SAN ANTONIO RIVERBOATS DRAWING SET APPENDIX G

NO.	ISSUE	DATE
1	ADDENDUM SET 1	1 September 2016

SAN ANTONIO RIVERBOATS
PROTOTYPE

BID SET
NOT FOR CONSTRUCTION

1 RUBRAIL

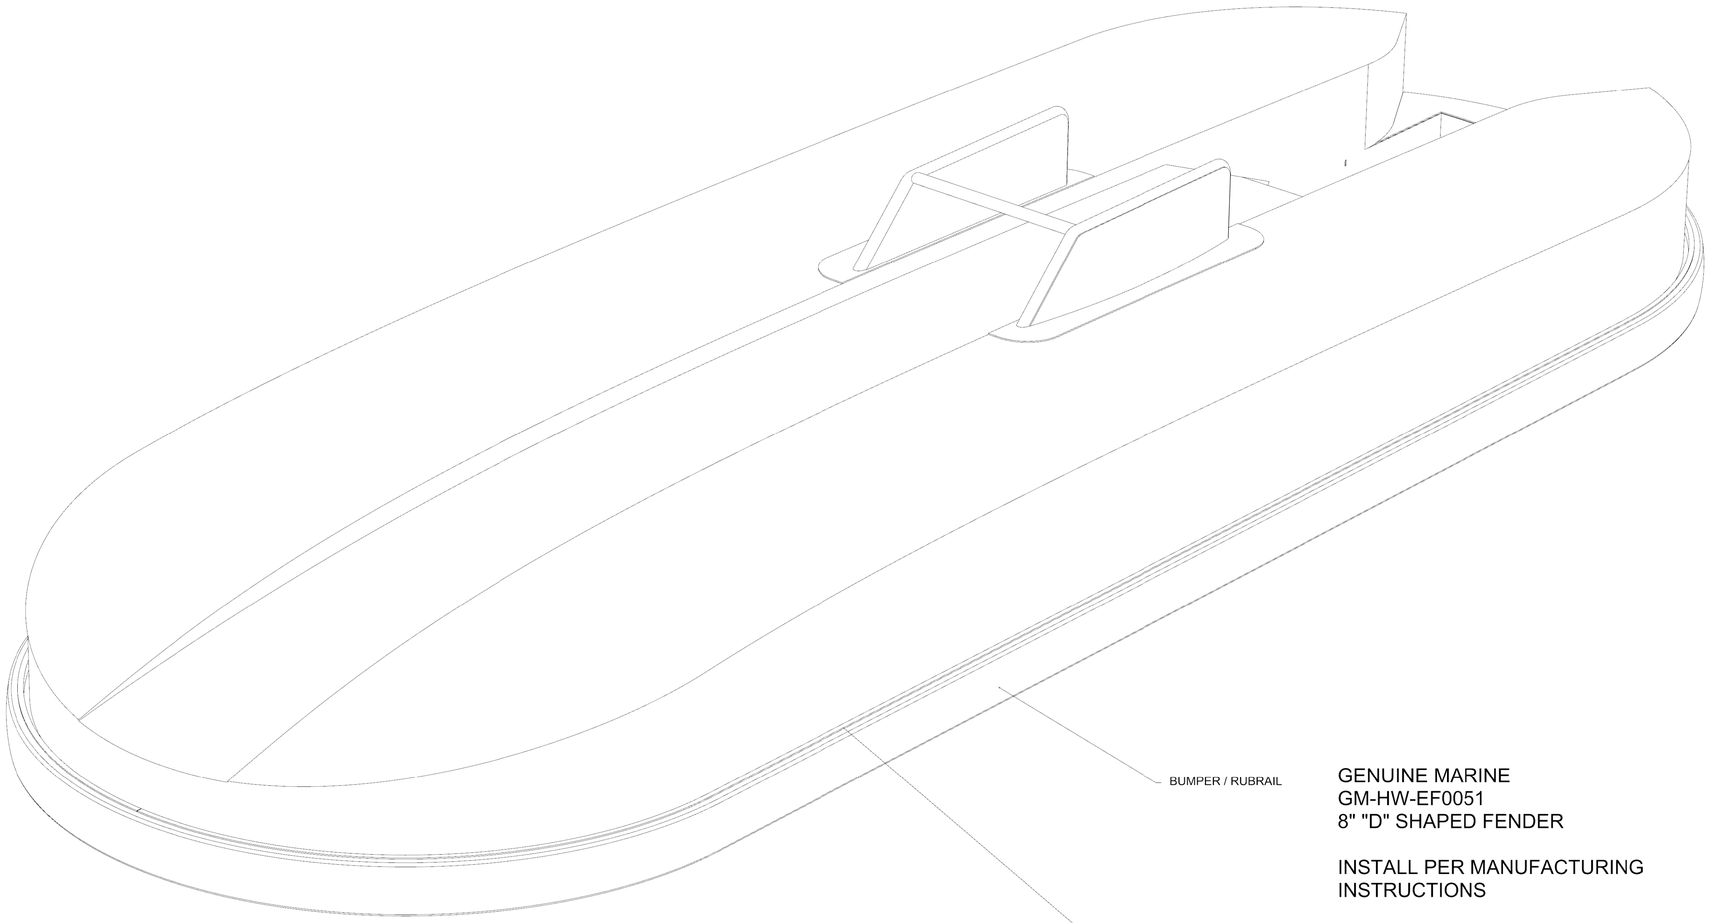
GENUINE MARINE
GM-HW-EF0051
8" "D" SHAPED FENDER

INSTALL PER MANUFACTURING
INSTRUCTIONS

PROTOTYPE BUMBER SECTION

REVISED BUMBER SECTION
